Design Improvement: 2022-2005 Ford F-250/F-350/ F-450/F-550 Super Duty Truck Front Right Outer Tie Rod

Brand	Supreme	Product	Tie Rod End	Date	February 2023
Part Number(s)	MS40622

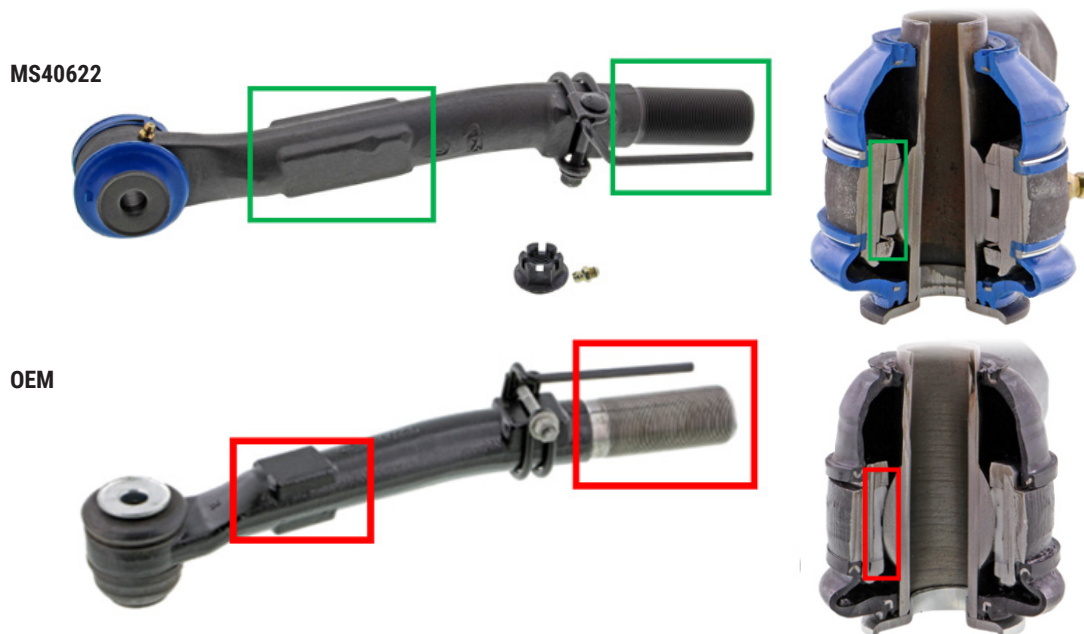
The OEM (including PNs: 5C3Z3A131HA/7C3Z3A131H/MEOE203) and other OE-style front right outer tie rod ends for the applications below utilize a non-greaseable plastic bearing and the original forging profile.

Mevotech Supreme front right outer tie rod end MS40622 is engineered with an improved forging profile which features a larger wrench flat surface. This part utilizes greaseable, self-lubricating upper and lower sintered bearings for extended part service life. Additionally, the larger wrench flat area and anti-corrosion threaded end improve ease of future alignment service. New hardware is included for a complete install.
